**ADDENDUM No. 3
(4 pages)**

LOS BANOS DOG PARK
CITY OF LOS BANOS

DATE: MARCH 17, 2020

LOS BANOS DOG PARK CLARIFICATION DRAWING - 1

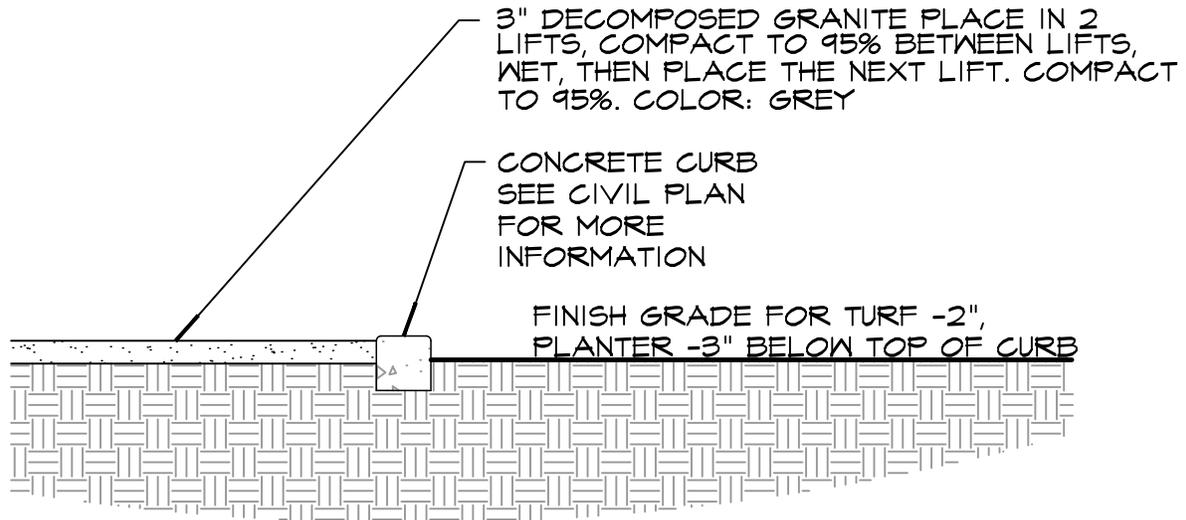
2. Please provide detail for 3" decomposed granite on sheet 2 of 5 - Demolition & Grading plan.

3. Please provide details for pipe trenching, irrigation sleeve; and detail and model for 2" gate valve.

Response: See Clarification Drawing 1, included herein.

Response: See Clarification Drawing 1, included herein.

PIPE TRENCH

2" BALL VALVE SPEARS TRUE UNION 2000, SR THREADED STYLE, 1829-020 SERIES, INSTALL PER MANUFACTURER'S STANDARD DETAIL.

DECOMPOSED GRANITE
